ADDENDUM # 1

DATE: April 11, 2025

**FOR: PCDL – NEW LEXINGTON
ADDITION & RENOVATION**

A-200

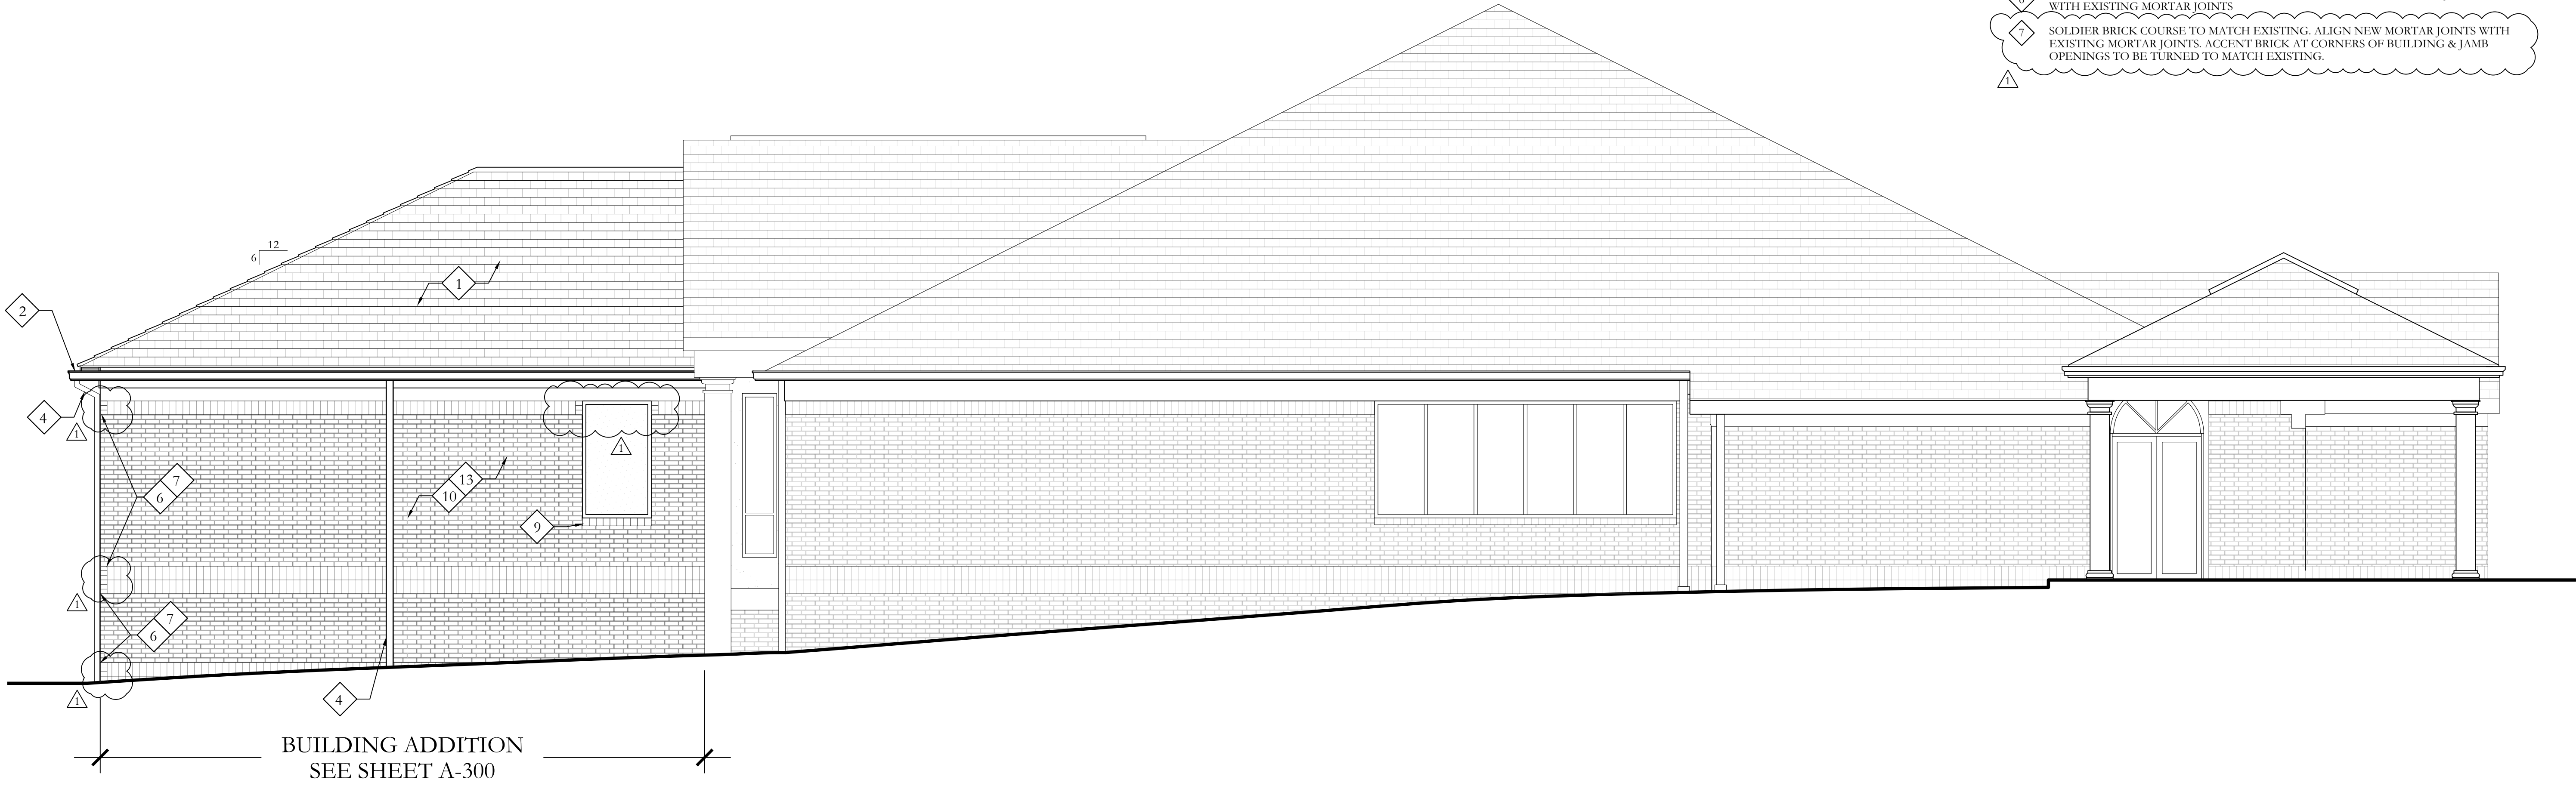
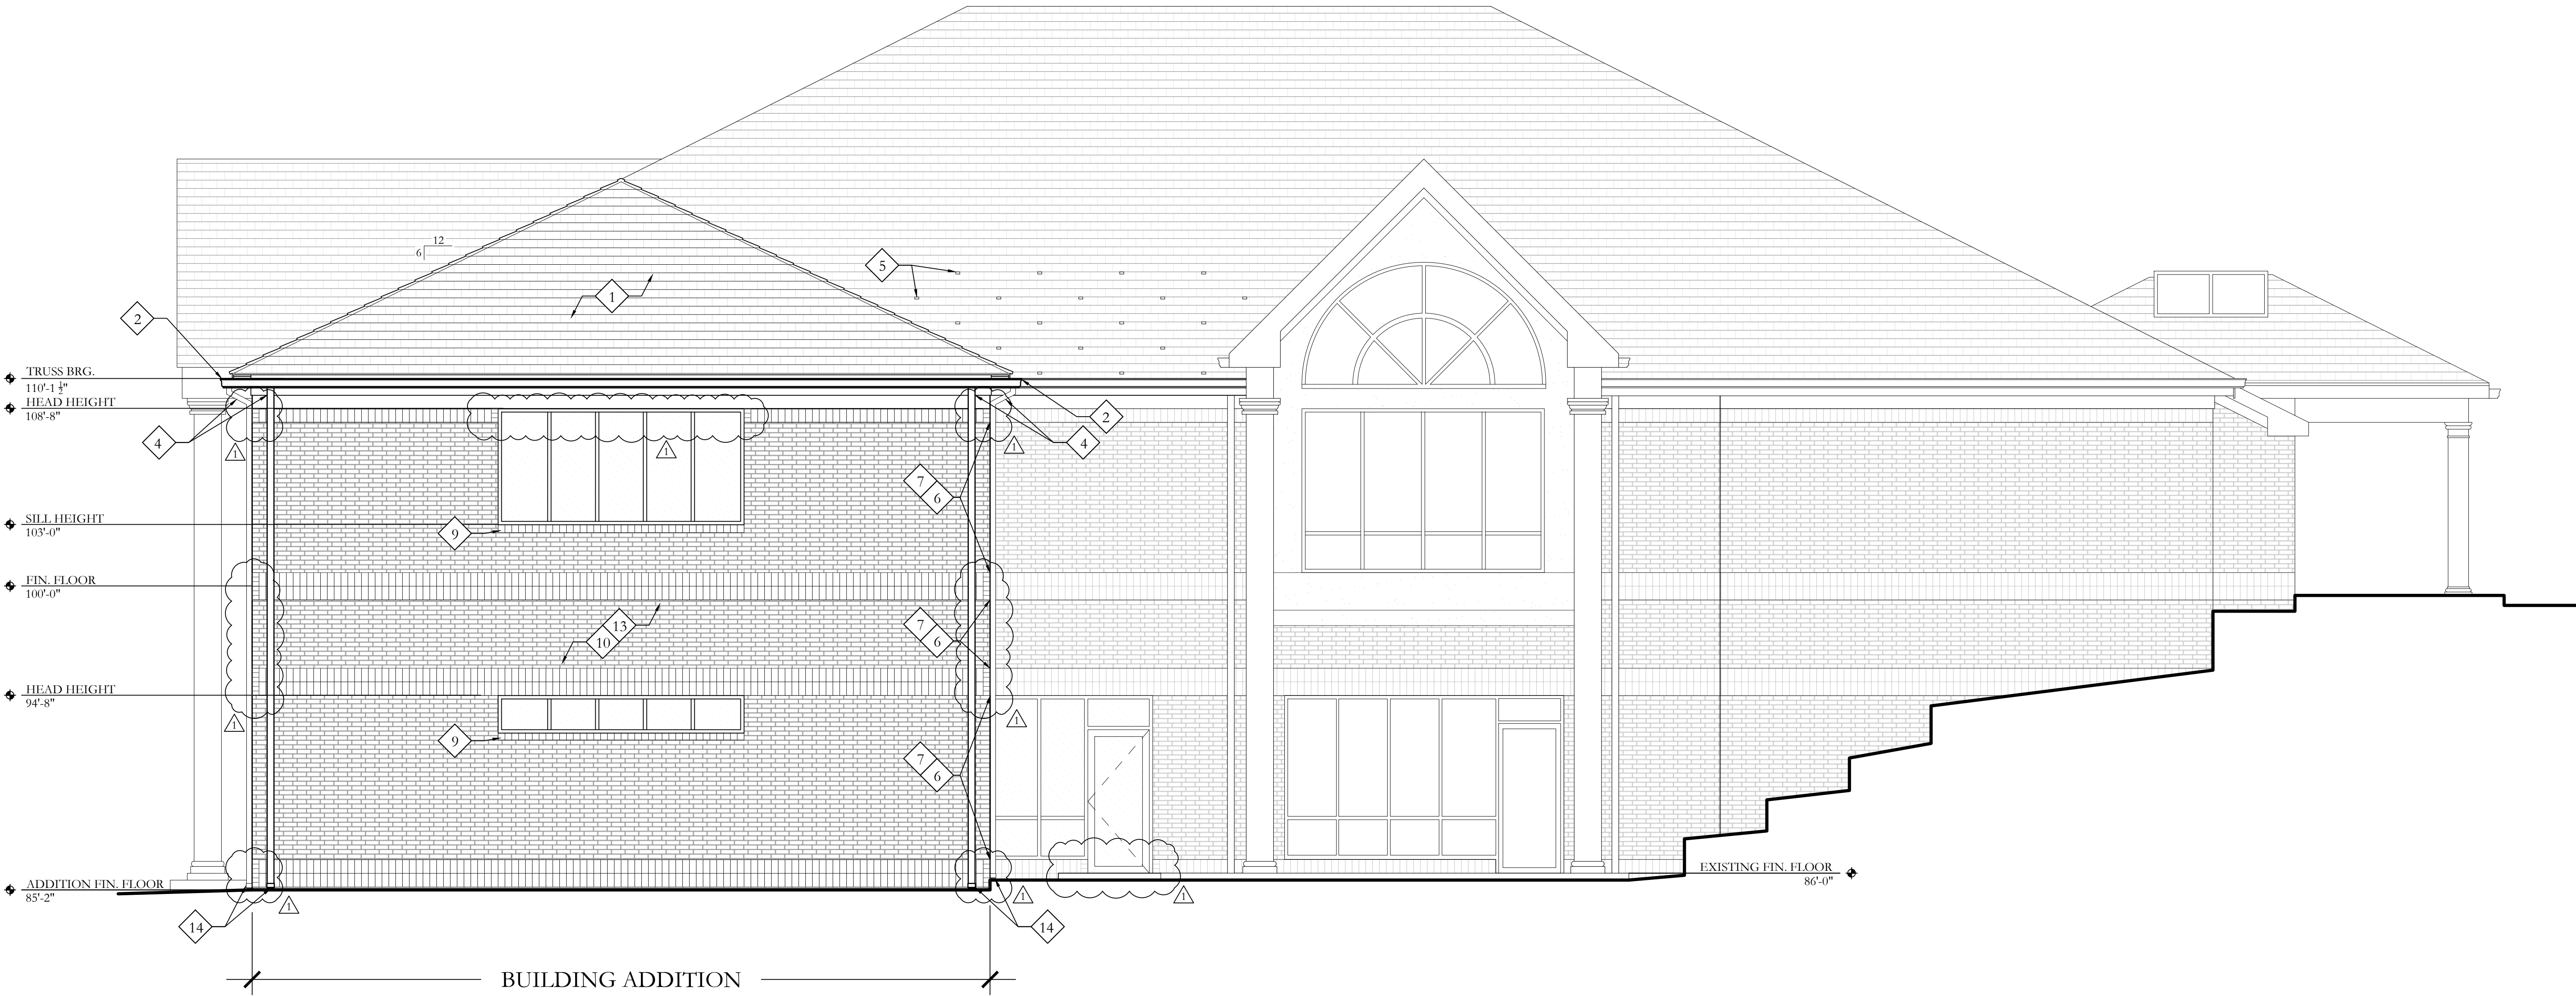
Item #7 New Construction Exterior Elevations – replace A-200 & A-201 with attached

- a. Base of window unit to be cut for relocated door #010C and brick to be turned around door frame

- b. Accent brick to be turned at corners of addition to match the existing
- c. Accent brick to be turned around frame of door #020A, #022B and upper-level windows to match existing
- d. Revised coded notes
